**Response to Comments
on the
Draft Environmental Impact Report
Edenglen Specific Plan
Ontario, California**

State Clearinghouse No. 2004051108

September 21, 2005

Exhibit 21 - Neighborhood Street Tapers

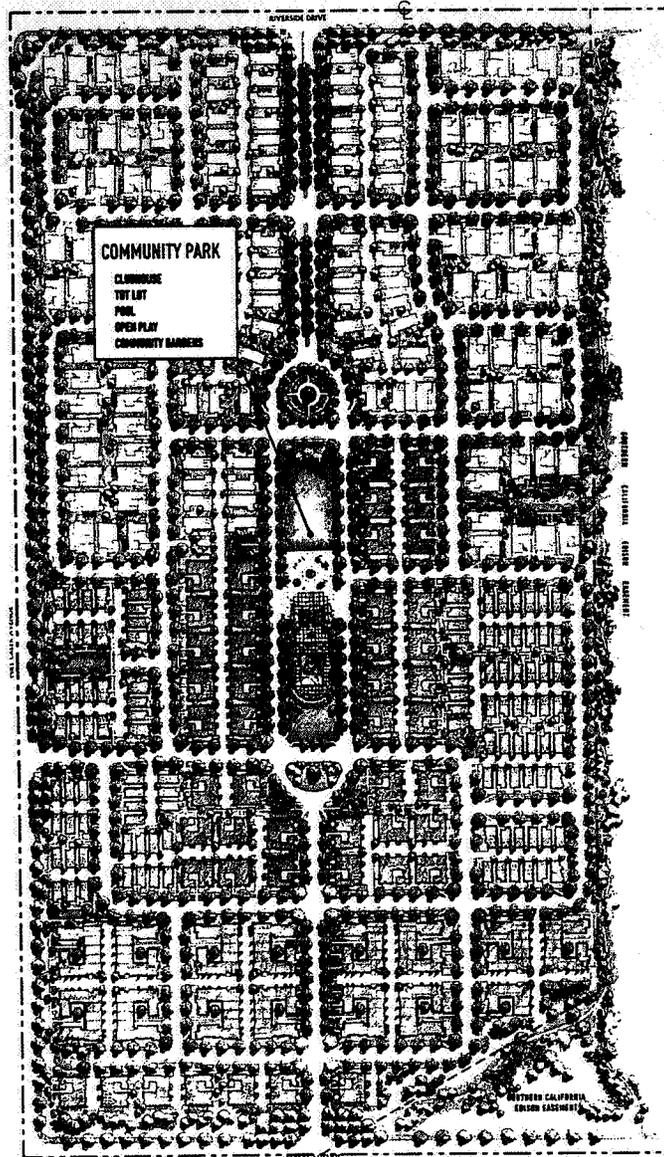
6.		5-13	<ul style="list-style-type: none">▪ Please revised Exhibit 21, Neighborhood Street Tapers to reflect the draft City Standard on Chokers with a 24 foot traffic calming opening and 6 foot parking on each side. The overall street width shall be maintained at 36 feet as shown.

13. Page 5-13. Exhibit 21 - Neighborhood Street Tapers. The exhibit shall be revised to show 24-foot wide tapers.
